IB-008 REV 1 2013-03-20

### AMBULANCE TYPE: 628XX AND 629XX series

TITLE : Alternator feed circuit breaker modification

# SERIE 628XX

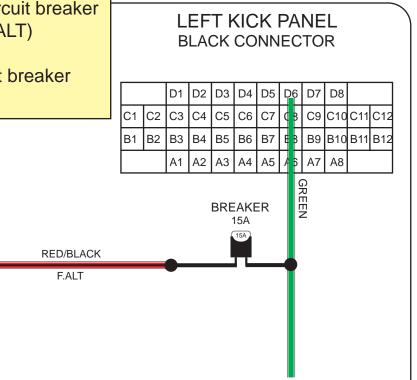
Locate and remove the circuit breaker on the red / black wire (F.ALT)

Install new supplied circuit breaker (E307400)
